SERVICE BULLETIN

M-846

POSITIVE BATTERY CABLE ROUTING 1982 FXR MODELS

Figure 1. Correct Battery Cable Routing

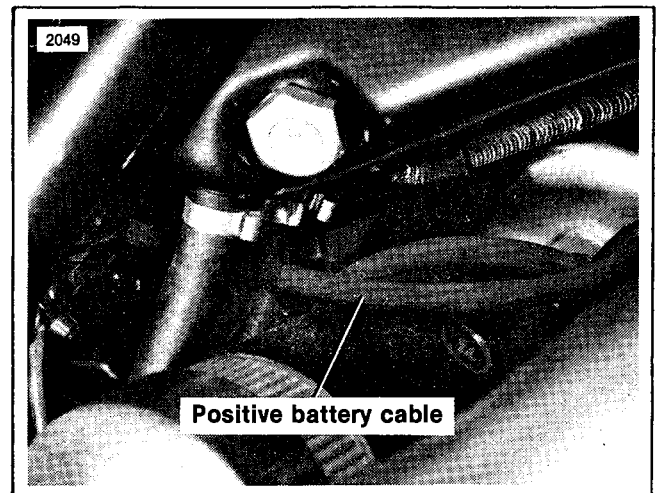
The positive battery cable on 1982 vehicles prior to VIN 1HD1EAK12CY112496, may contact the bottom edge of the battery carrier. This surface could cause premature wear of the cable insulation resulting in an intermittent short circuit.

See Figure 1. Reroute the positive battery cable between the second and third oil hoses leading from the oil tank.
